BARANGAROO SOUTH

Stage 1B Public Domain Modification S4.55

Project
BARANGAROO STAGE 1B
PUBLIC DOMAIN
Modification S4.55

Drawing Title
**WULUGUL WALK
MASTERPLAN - NO TREES**
Drawn
SS

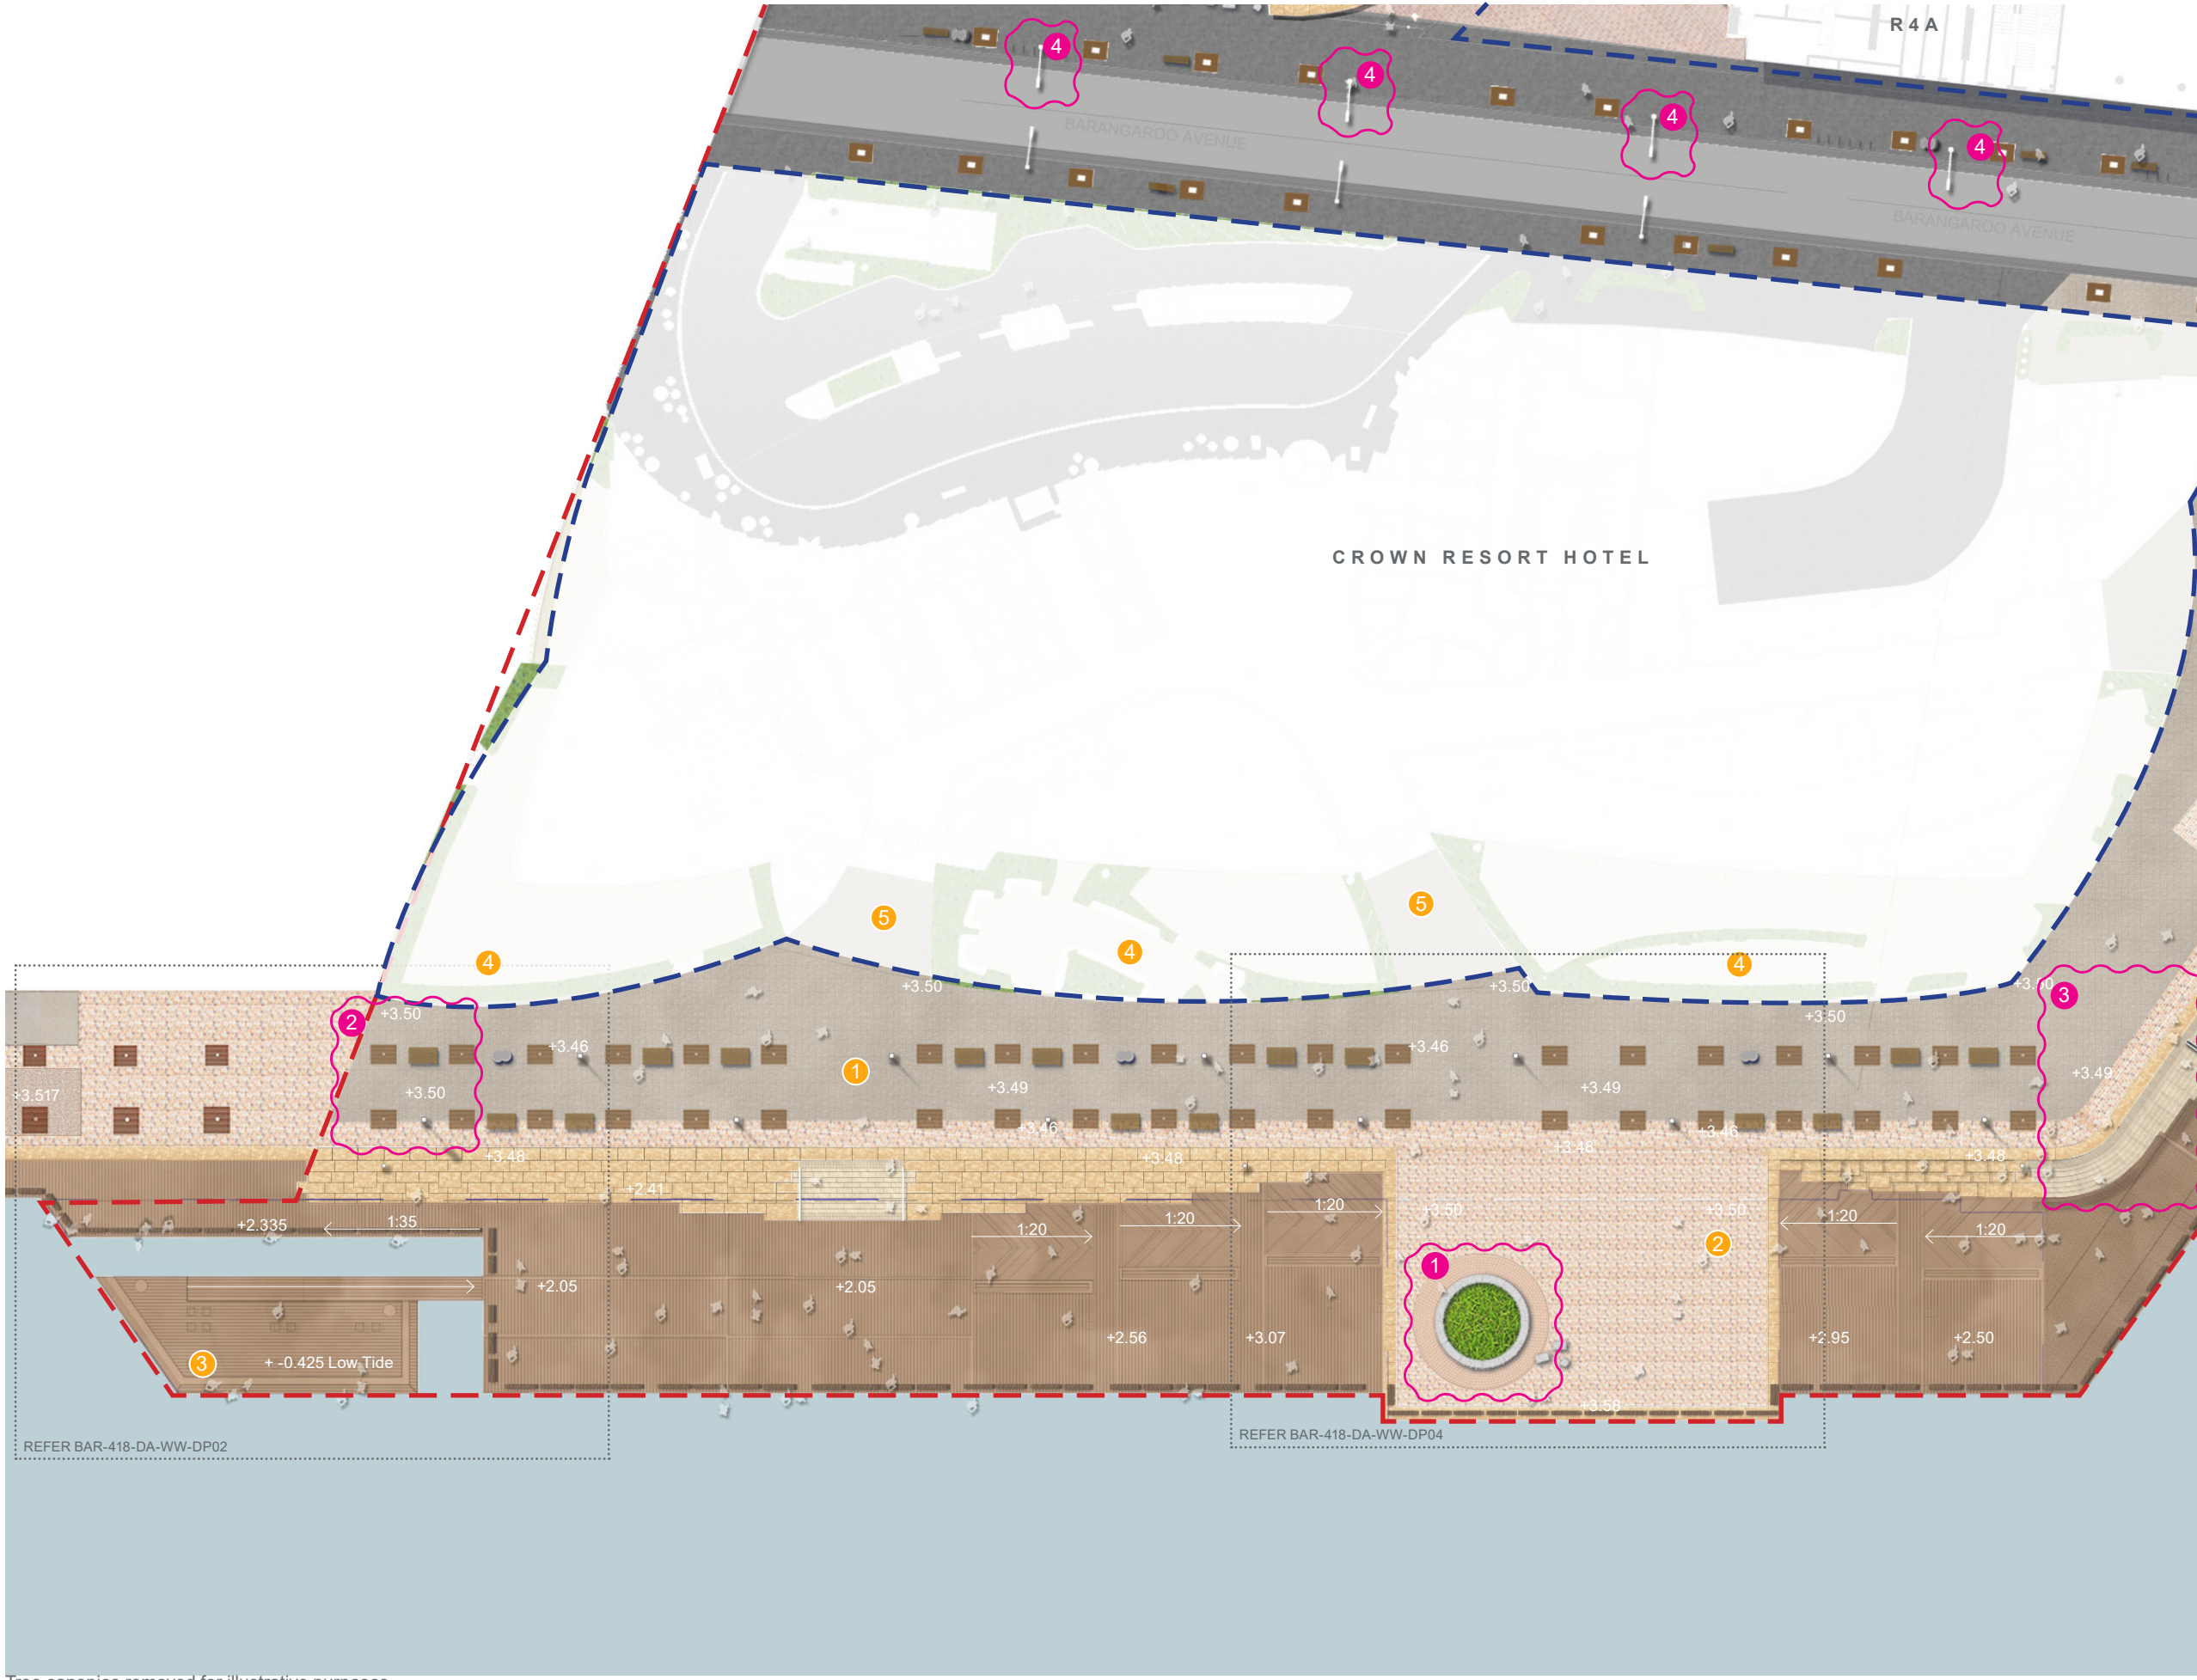
- Proposed Modifications**
- Amendment cloud
 - 1 Remove timber top for Sprit of Tasmania loading dock raised planter seating
 - 2 No porphyry paving at Northern end of Wulugul walk
 - 3 Stone stairs changed to concrete
 - 4 Additional smart pole

Drawing Title
**WULUGUL WALK & SPIRIT OF
TASMANIA LOADING DOCK
DETAIL PLAN - NO TREES**
Drawn
SS

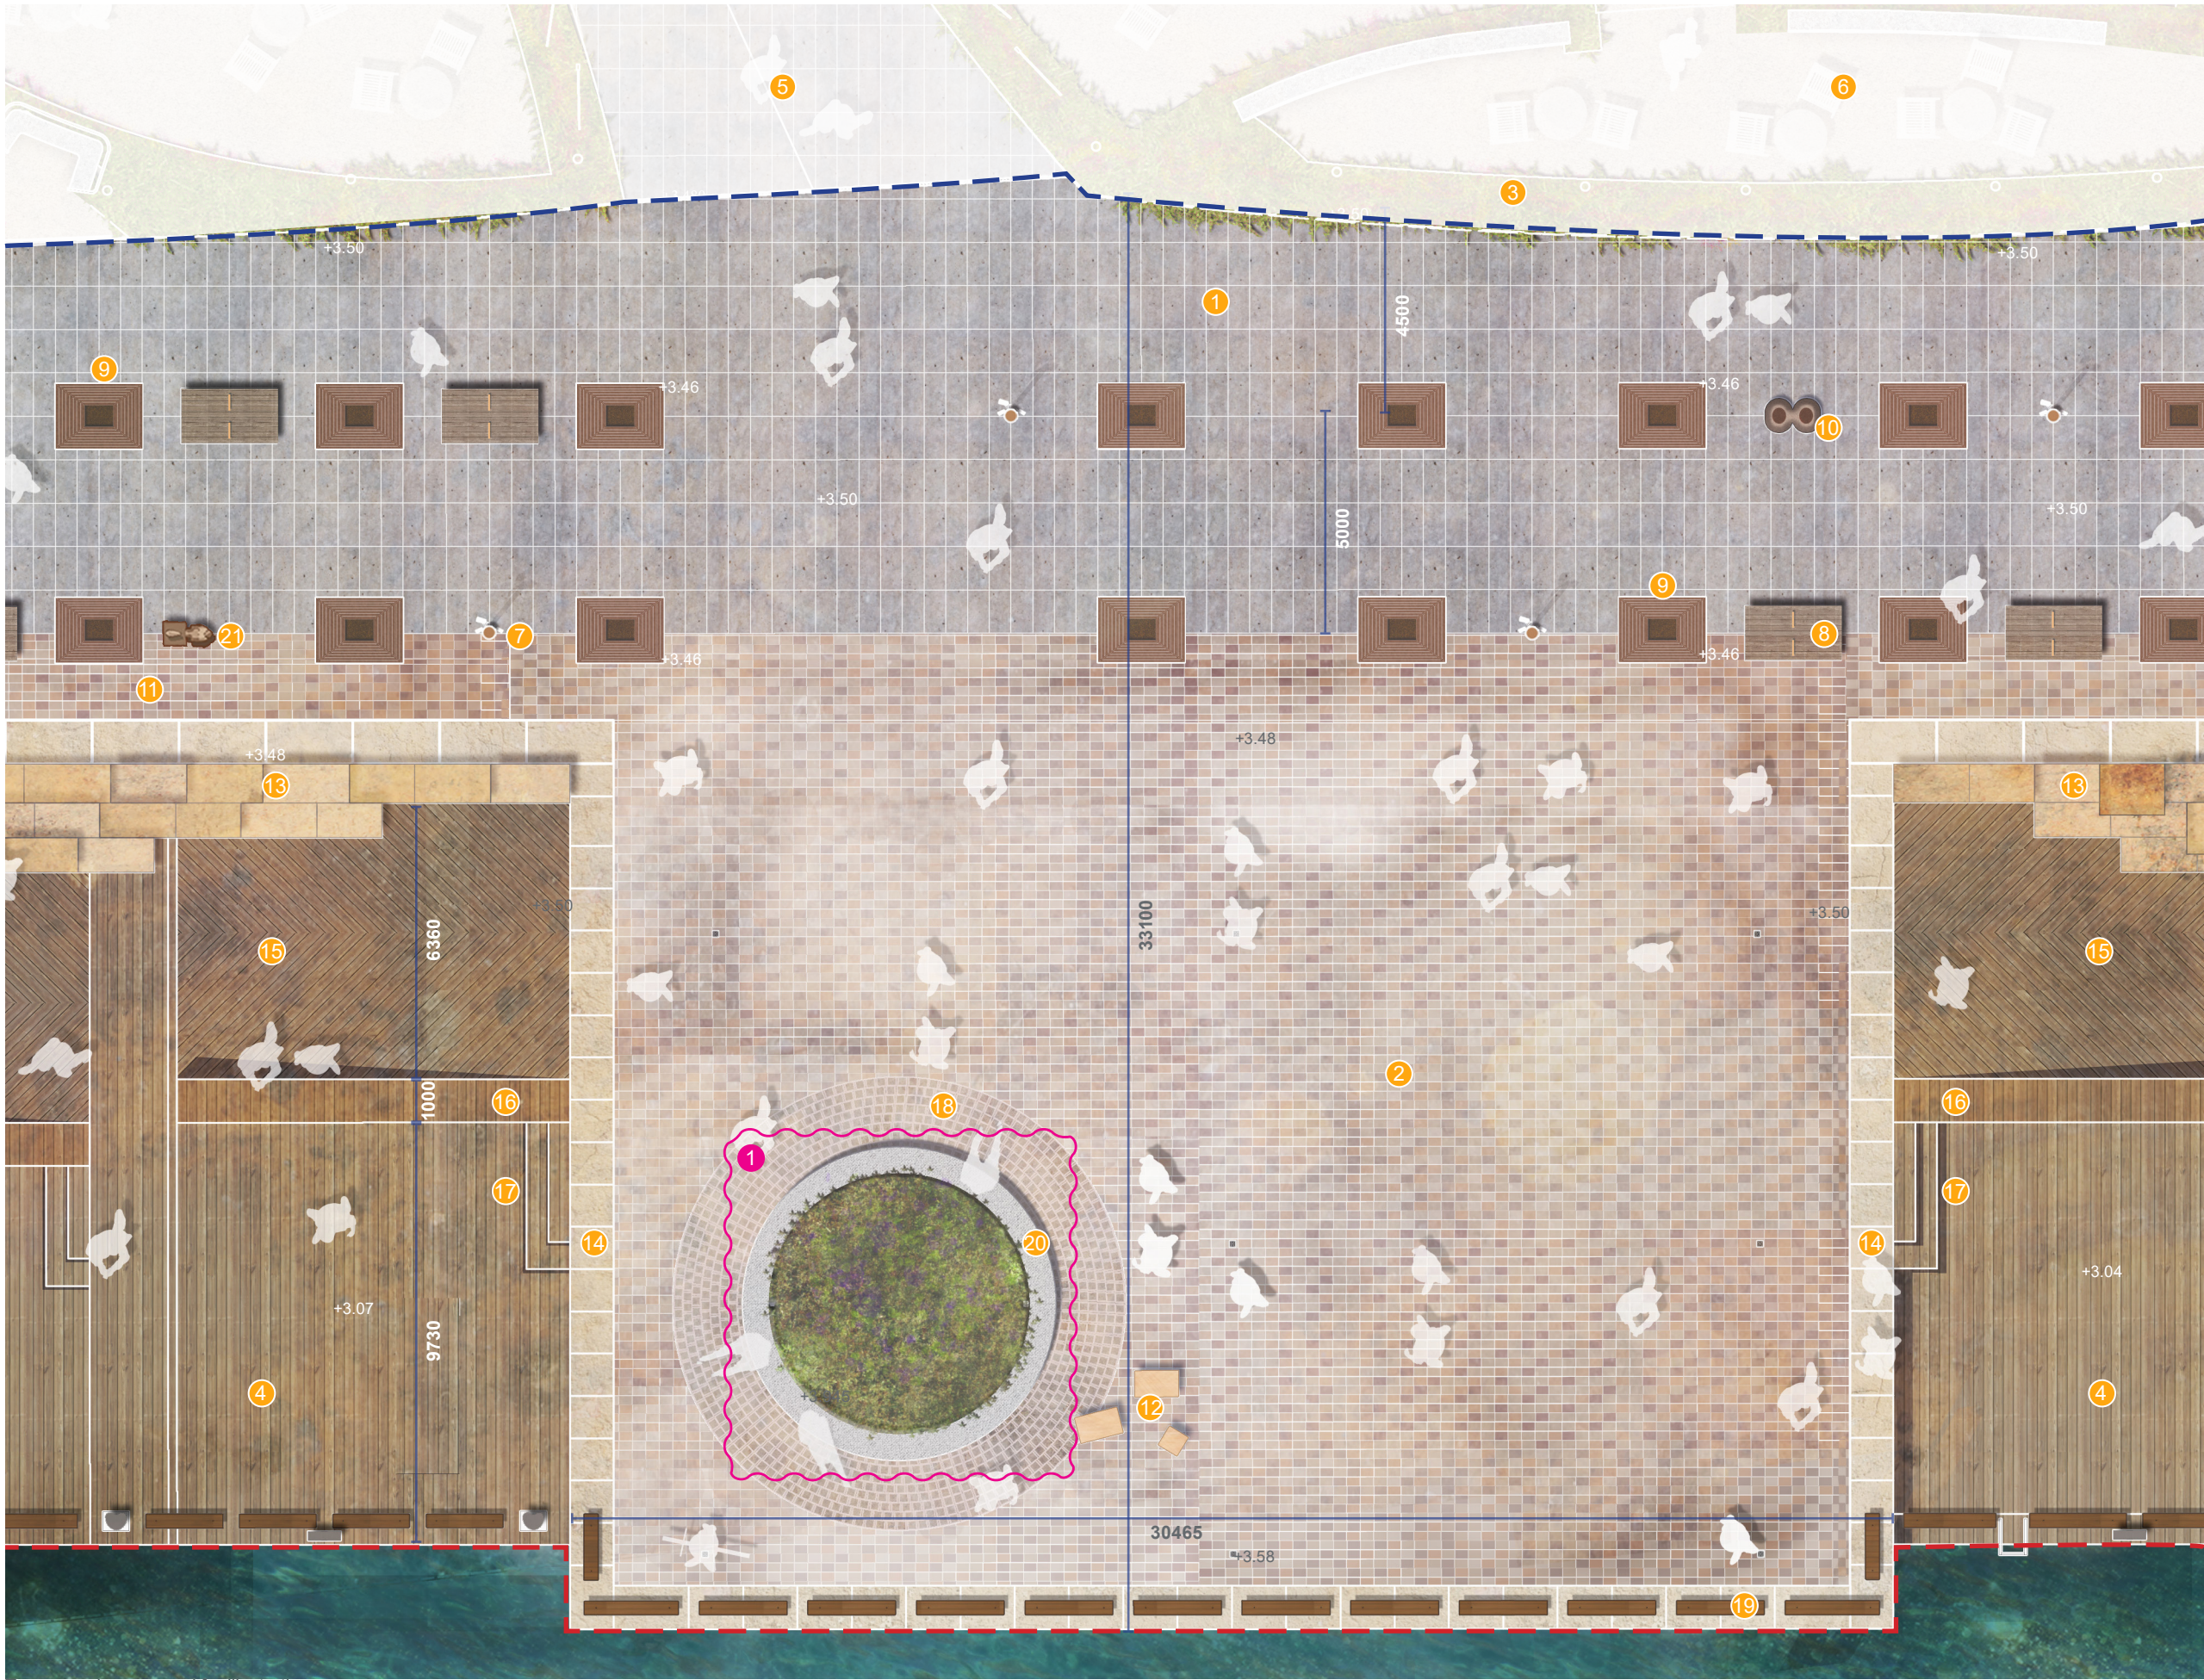
- Remove timber top for Sprit of Tasmania loading dock raised planter seating

Drawing Title
WULUGUL WALK
SECTION E - E

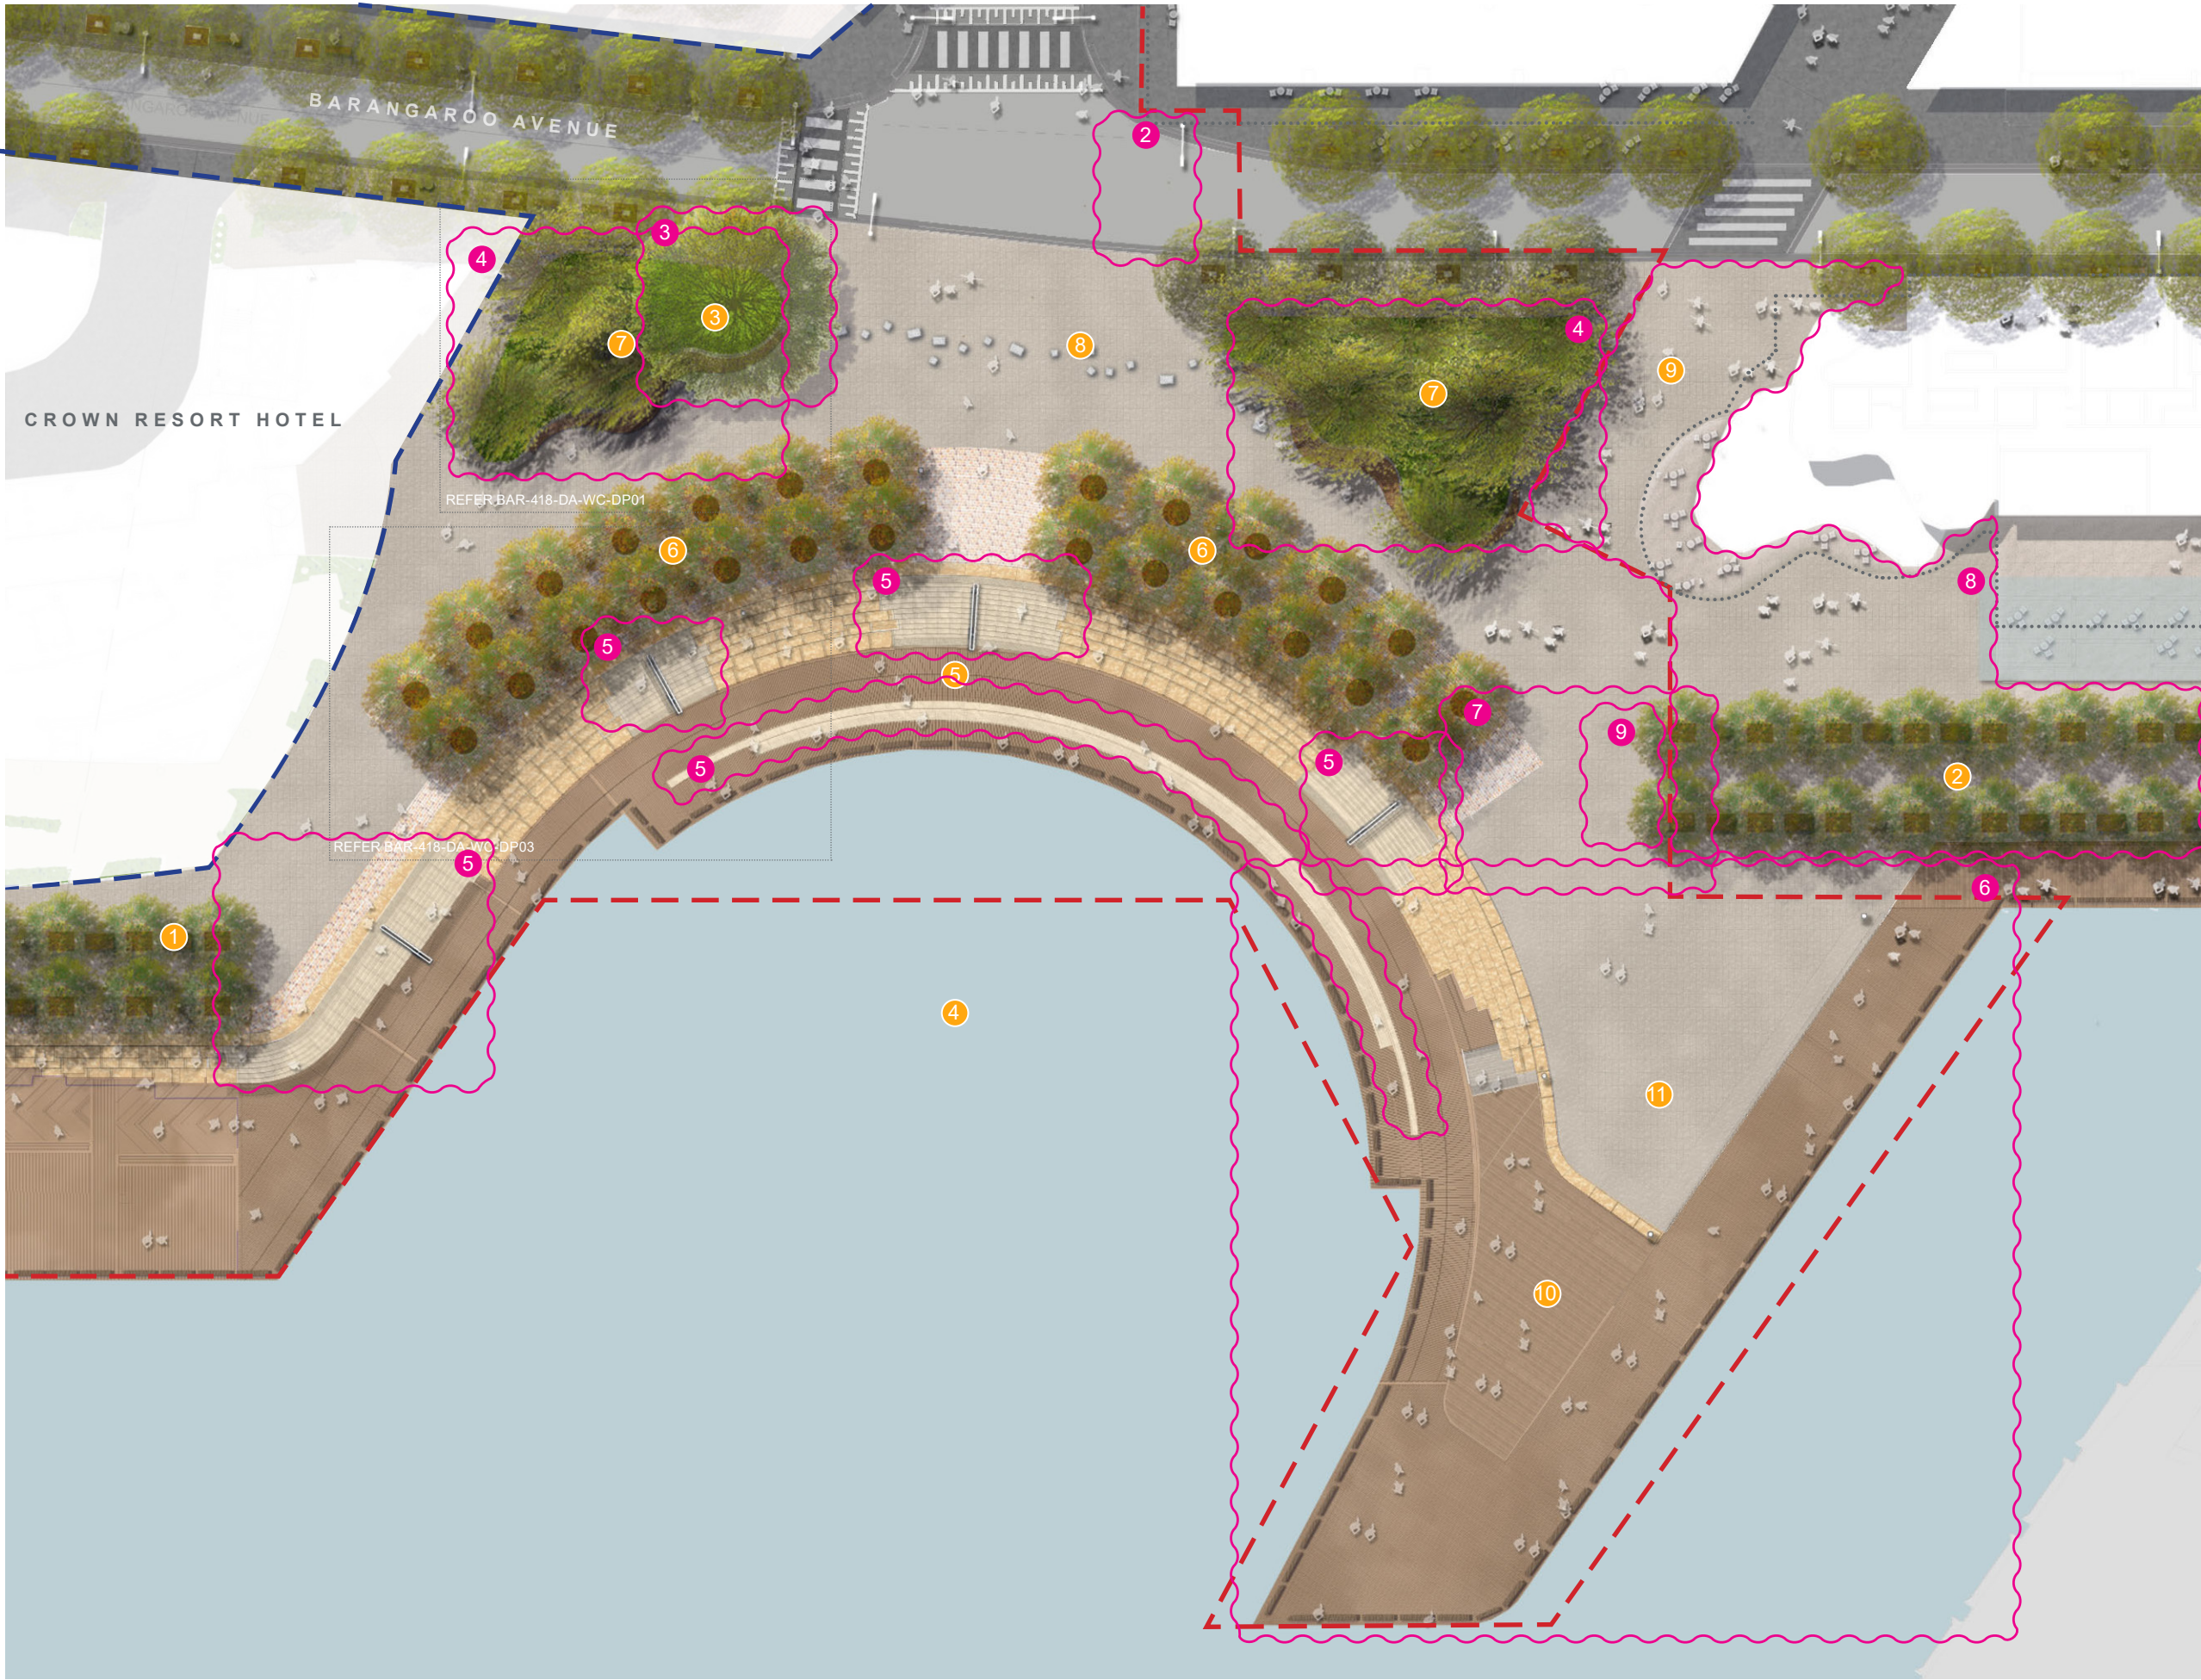
-  Amendment cloud
- 1** Remove timber top for Sprit of Tasmania loading dock raised planter seating
